**Board Report**

**PLANNING AND PROGRAMMING COMMITTEE
OCTOBER 14, 2020****SUBJECT: LOS ANGELES UNION STATION FORECOURT AND ESPLANADE
IMPROVEMENTS****ACTION: APPROVE RECOMMENDATION****RECOMMENDATION**

APPROVE the Addendum No. 2 to the Final Environmental Impact Report for the Los Angeles Union Station Forecourt and Esplanade Improvements Project.

RE: SC# 2016121064 Los Angeles Union Station Forecourt & Esplanade Improvements Project, EIR Addendum #2

1. Adjustments to Shade Cover:

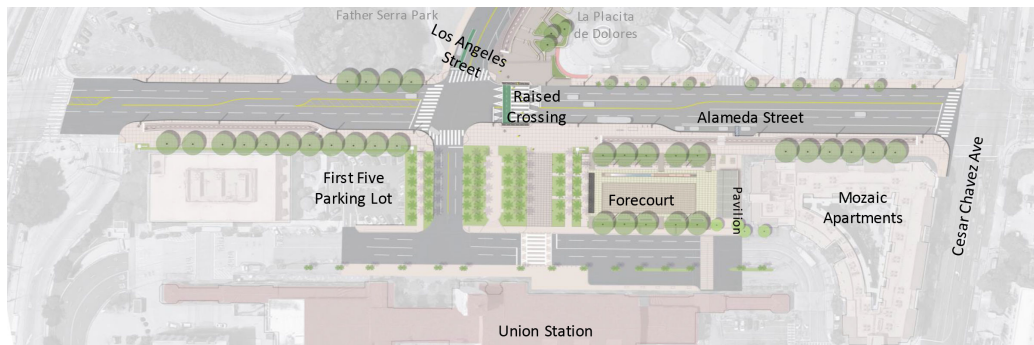
The 2015 Union Station Master Plan (“Transforming Union Station”) presented a vision for the improved pedestrian experience in accessing Union Station from Alameda Street. This plan called for the installation of new double-rows of mature sidewalk trees providing shade cover from midday sun. The plan showed 76 mature sidewalk trees located in double-rows to enhance the pedestrian experience, aesthetics, and usability of these sidewalks on hot days.

As climate change continues to impact Southern California, Los Angeles residents and visitors are increasingly becoming familiar with 100°+ Fahrenheit days for longer periods and more regularly throughout the year. At these temperatures, it is absolutely critical to provide the relief of shade cover for people not enclosed in air-conditioned vehicles, including pedestrians, bicyclists, and people with disabilities on whom the project is focused.

With adjustments to the proposed roadway configuration of Alameda Street, Metro is now proposing to eliminate 50 of the originally planned 76 Alameda sycamore or similar shade trees (a reduction of 28 from the 54 trees on Alameda referenced in the adopted 2018 FEIR). Additionally, the revised plan shows 17 more trees relocated away from the center of the sidewalk to the edge of the Metro property line. These combined changes in reduction and relocation of shade trees result in a significant reduction in the amount of shade cover provided to pedestrians and bicyclists in accessing Union Station.

Addendum #2 Section 5.1.1 states, “These elements would not result in any impacts to any trees along Alameda Street that were not already accounted for in the Approved Project. Therefore, the Alameda Esplanade revisions would result in no impacts to aesthetics.” This statement is obviously false in review of Metro’s design presentation, proposal to eliminate double-rows of trees, and provision of only 26 mature shade trees on Alameda in place of 76 as envisioned. Metro must study the aesthetic impact of this large reduction in mature sidewalk trees, study the resulting

changes in temperature along non-shaded areas during heat waves, and provide alternatives to improve aesthetics and sidewalk temperatures for non-vehicular users.

5. Stormwater Runoff:

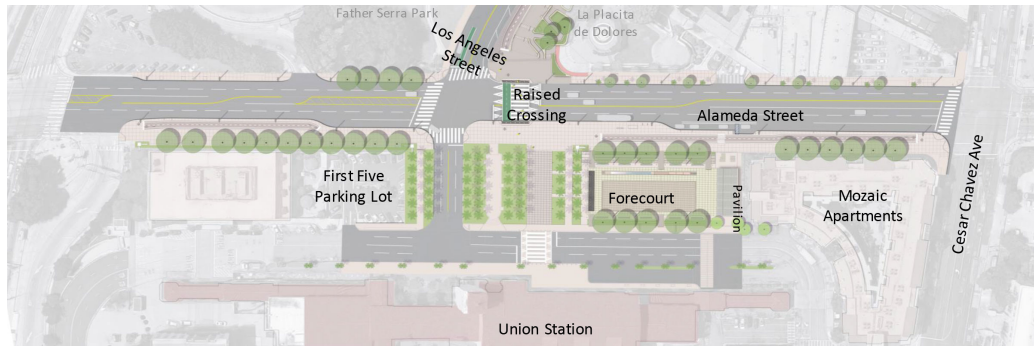
Addendum #2 Section 5.10 "Hydrology and Water Quality" provides no study to support its statement that a reduction in the number of mature trees and permeable surface area of landscaping has "No Impact" to stormwater runoff from the project scope adopted in the 2018 FEIR. If Metro seeks to eliminate 52% of mature sidewalk trees (28 of 54), Metro should provide a stormwater runoff study to justify that the
